TOLEDO - LUCAS COUNTY PLAN COMMISSIONS

REF: PUD-10003-23
DATE: January 12, 2024

SUBJECT: Planned Unit Development for Multiple Commercial Buildings on a Lot at 0 Glendale Avenue

SITE PLAN

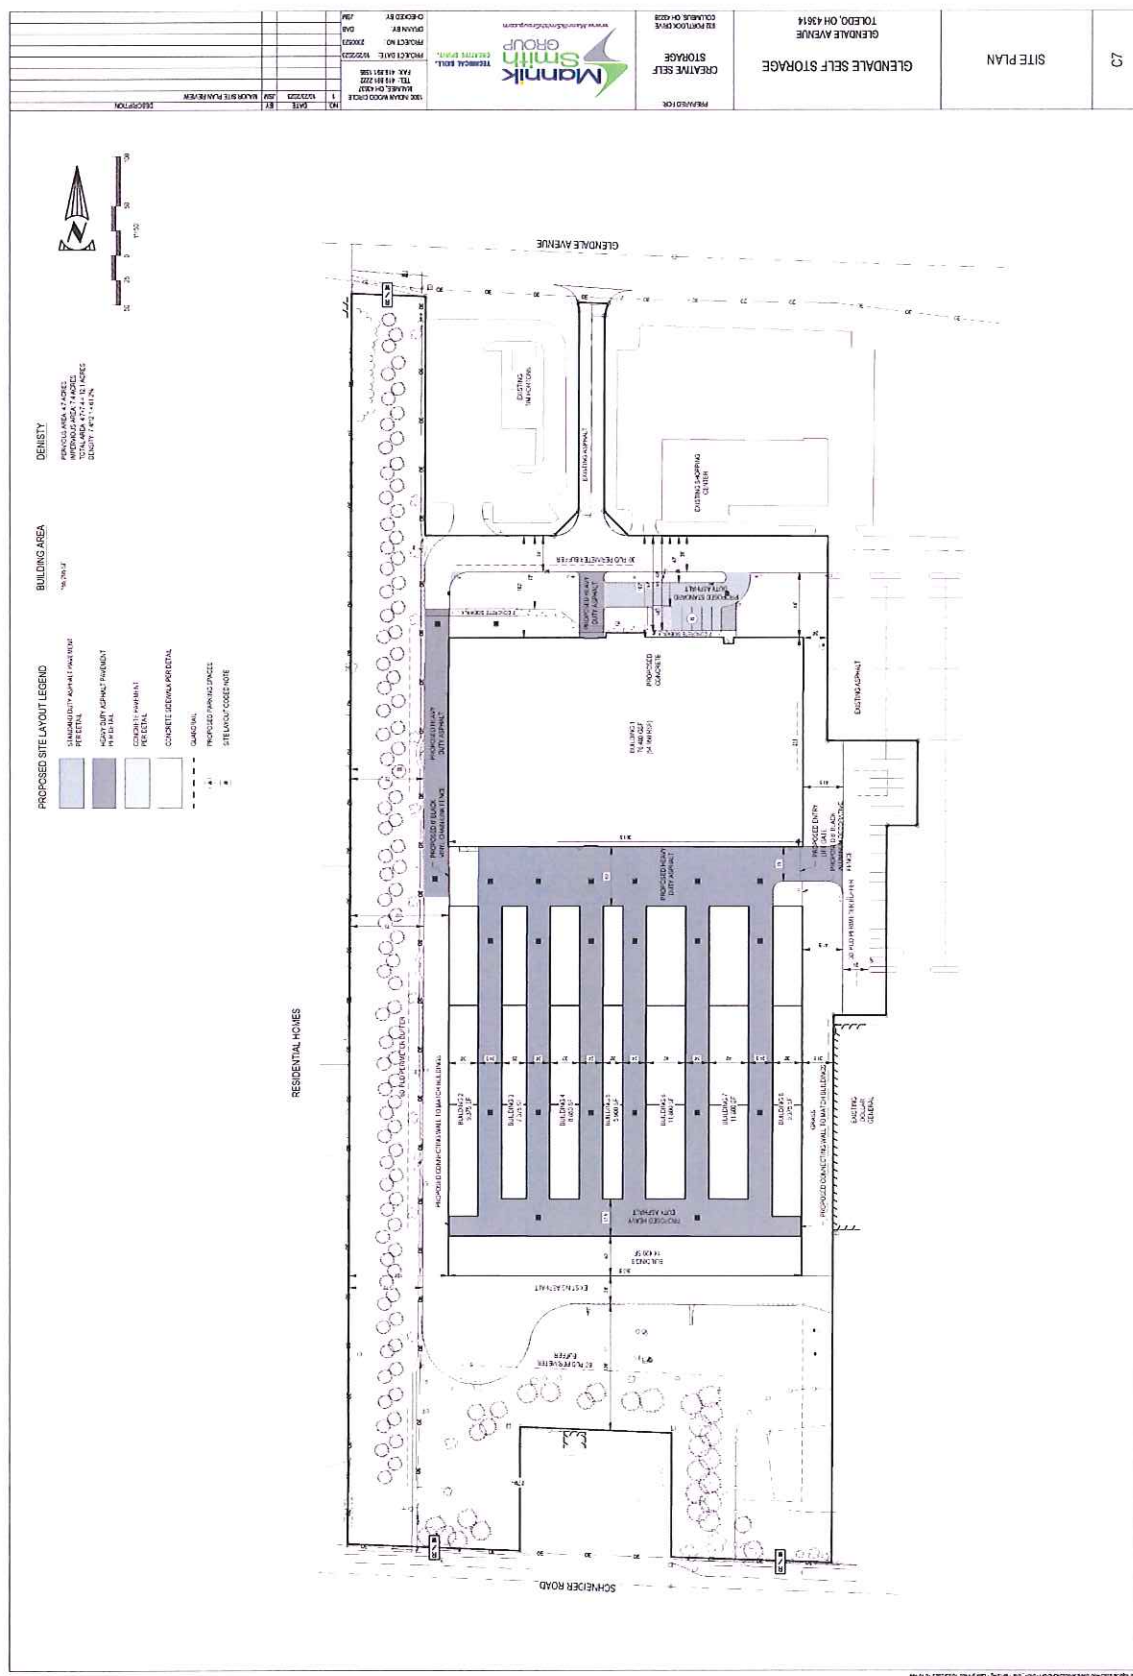
Access to the development is through an existing drive entry from Glendale Avenue to the Toledo Commons Shopping Center located between Tim Hortons and the multi-tenant shopping plaza at 3043 Glendale Avenue. The Applicant is proposing an access easement to allow for all vehicles entering the Toledo Commons Shopping Center to maneuver around the site similarly as they do presently. The exception will be that access to the area with the self-storage units will be limited to renters of the units. Those accessing the indoor storage will enter through an overhead door on Building 1 in the front, continue through the building to an overhead door on the back of the building, and exit the site through a gate on the east side of the property. The renters accessing the outdoor storage units will enter and exit through the gate on the east side of the property. As reflected on the site plan, the interior of the site will be enclosed on the east side of the site with a 6-foot black aluminum fence and entry lift gate between Building 1 and Building 8 and on the west side with a 6-foot black vinyl chain-link fence between Building 1 and Building 2. In addition, a 6-foot wall that matches the outdoor storage buildings is proposed to connect Building 9 and Building 8 on the east and Building 9 and Building 2 on the west. Staff recommends that both sections of fencing be the proposed 6-foot black aluminum fencing.

Upon review of the submitted plan, the Division of Transportation noted that 25-foot driveways and drive aisles are required for two-way traffic per TMC§1107.1911. The drive aisles between the outdoor storage buildings (Building 2 - Building 8) do not meet this requirement. The aisles as proposed vary from 24 feet to 24.5 feet in width. In a discussion with the Division of Transportation, it was determined that the deficiency of a half of foot to one foot in aisle width would be acceptable in this circumstance. This determination was based on the type of use and the fact that the site will not be open to the general public, but limited to renters of the storage units.

- Per TMC§1107.0304 a self-storage facility is required to have 4 parking spaces plus 1 parking space per 250 rental spaces. There are a total of 922 storage units, which equates to 4 spaces, for a total requirement of 8 parking spaces. Based on these 8 required spaces, 2 bicycle spaces are required and 1 accessible van space (TMC§1107.1701). The site plan illustrates 6 parking spaces at the front of the building, one of which is an accessible van space. Additional spaces are provided to the east that are in excess of the required 8 spaces; therefore, the proposal is in compliance with the minimum number of required off-street parking spaces. Bicycle parking is however not provided. A provision for 2 bicycle parking spaces is needed to meet this requirement.

- Per TMC§1103.1010(D) PUD developments are required to provide sidewalks, built to city specifications along both sides of all streets, public or private. Sidewalks or other approved pedestrian walkways must be provided to link nonresidential areas with residential areas, both inside and outside the PUD. The proposal is providing for a sidewalk in front of Building 1 from the entry, north to an existing sidewalk along the west property line, that extends from Glendale Avenue to Schneider Road. To complete this connection, a sidewalk needs to be provided from the entry east to the edge of the property, to connect to the existing shopping center. This will provide for access to the existing parking spaces to the east.

35. The material for both the proposed 6-foot black vinyl chain-link fence and the 6-foot black aluminum decorative fence and entry gate shall be the same. The fences and entry gate shall be decorative black aluminum and shown as such on a revised site plan and landscape plan.

36. Per TMC§1107.0304, the Off-Street Parking Schedule requires one bicycle parking slot per 10 parking slots. No bicycling parking is proposed. A minimum of two bicycling slots shall be shown on a revised site plan.

37. Per TMC§1103.1010(D) PUD developments are required to provide sidewalks, built to city specifications along both sides of all streets, public or private. Sidewalks or other approved pedestrian walkways must be provided to link nonresidential areas with residential areas, both inside and outside the PUD. To provide a complete connection, a sidewalk shall be provided from the front entry of Building 1, east to the edge of the property, to connect to the existing shopping center. The sidewalk shall be shown on a revised site plan.
